HARTFORD PLANNING COMMISSION

Meeting Notice and Agenda

**Application #24-11 by 12 Tremont Street, LLC and Tim Sidore
for Final Approval of a Planned Development
for a Multi-Unit Dwelling, lot 09-0072-000
1200 Christian Street, Hartford, in a R-3 zoning district**

Application #24-12 by 12 Tremont Street, LLC and Tim Sidore for Site Development Plan Approval to convert an existing structure into a Multi-Unit Dwelling lot 09-0072-000, 1200 Christian Street, Hartford, in a Planned Development

FIGURE 1: PROPOSED SITE PLAN (ENGINEERING VENTURES DATED 7/8/24) WITH WCG NOTES

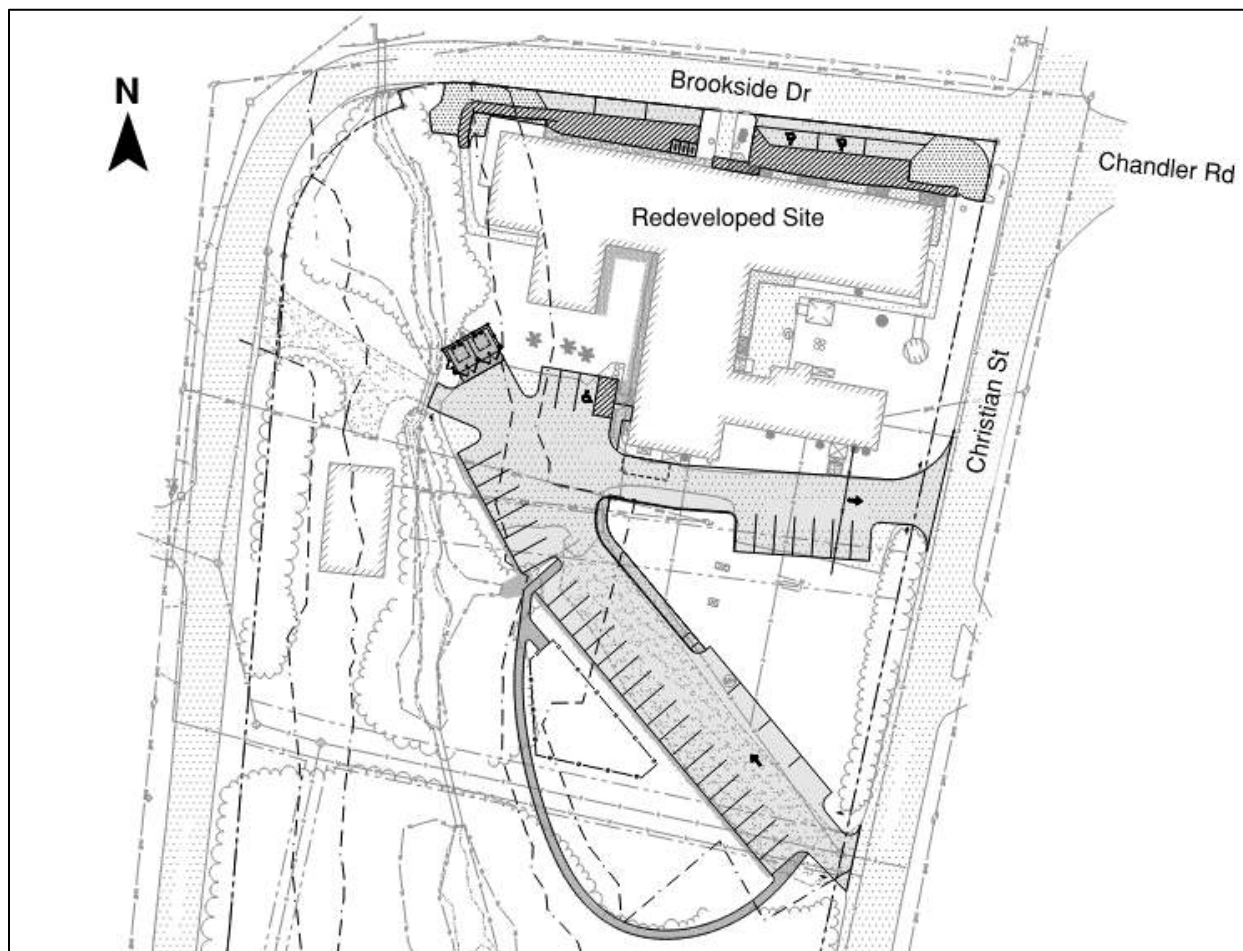
The former site included approximately 24 head-in parking spaces along Brookside Drive on the northern property boundary. The current plan indicates these spaces will be redeveloped as six parallel parking vehicle spaces, and three U-style bicycle racks with a capacity for six bikes.

The existing site plan includes access through the site from Christian Street to Brookside Drive. The proposed site plan indicates this access is maintained in the proposed build condition.

- The following recommendations should be implemented to ensure safe and efficient transportation access to the site:
 - Remove the high-growing shrubs and maintain landscaping to improve the sight line to the south from the northern driveway site access at Christian Street.

- Shift the parallel parking and / or trim the vegetation on the inside corner of Brookside Drive to provide 115 feet of stopping sight distance on approach to the on-street parallel parking spaces.

- The site design team should consider the following suggestions to improve transportation access to the site:
 - Avoid low growing shrubs, plantings, signs, or other features that may impact sight lines at the driveway and Brookside Drive intersections onto Christian Street.
